# 1963 - 1965 Corvette: Service Bulletin: Drive Line Noise

**Subject:** Drive Line Noise  
**Model and Year:** 1963 - 1965 Corvette  
**Source:** Chevrolet Technical Service Bulletin  
**Bulletin No:** #1069  
**Section:** IV  
**Date:** January 7, 1965

FIGURE 1

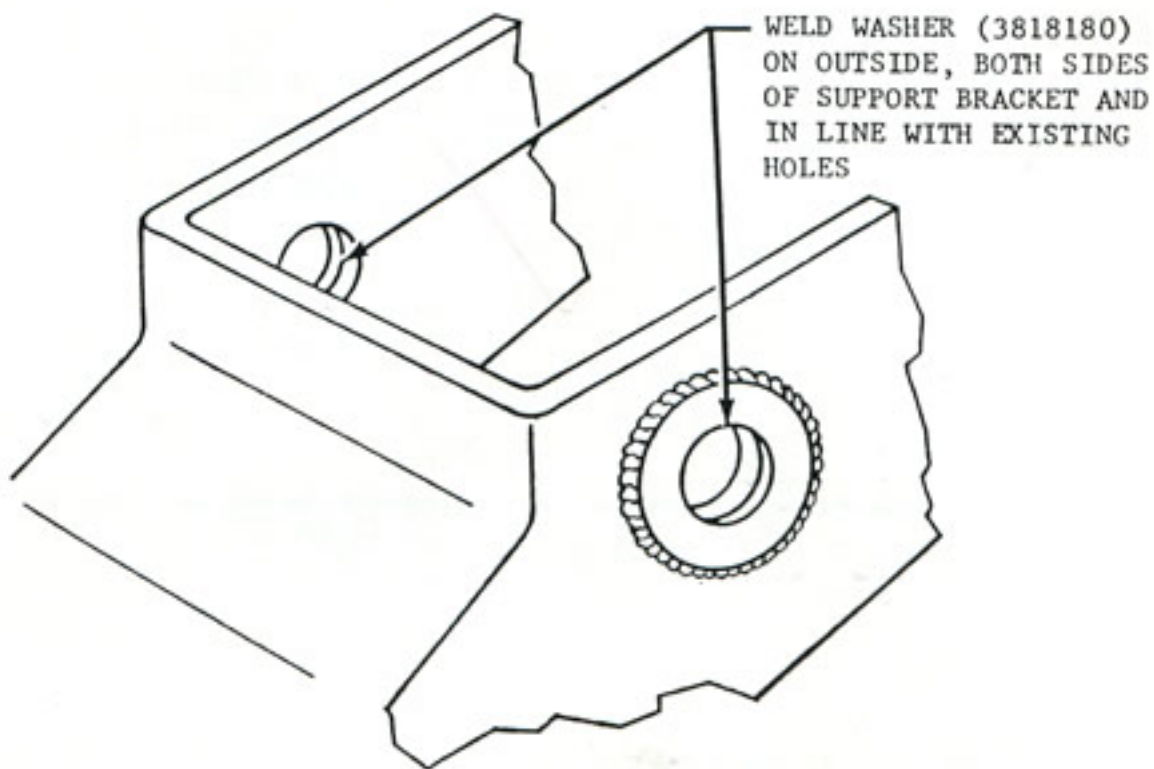
A clunking noise may occur in the drive line of some 1963-65 Corvette on initial vehicle movement in either forward or reverse gear. This could be caused by loosening of the differential carrier support bracket front attaching bolts. Loosening of these bolts will also result in elongation of the bracket bolt holes.

If elongation of bracket bolt holes occur, the differential carrier bracket should be replaced with bracket Part No. 3868799. However, the original service bracket Part No. 3820186, can be used by reinforcing it as shown in Part I of this bulletin. In conjunction with the installation of the bracket, it will be necessary to secure the forward attaching bolts as outlined in Part II of this Bulletin.

1. If reinforced bracket, Part No. 3868799 is not available, obtain Part No 3820186 and weld one flat washer, (Part No. 3818180) on each outside surface in line with existing holes (See Figure 1.)
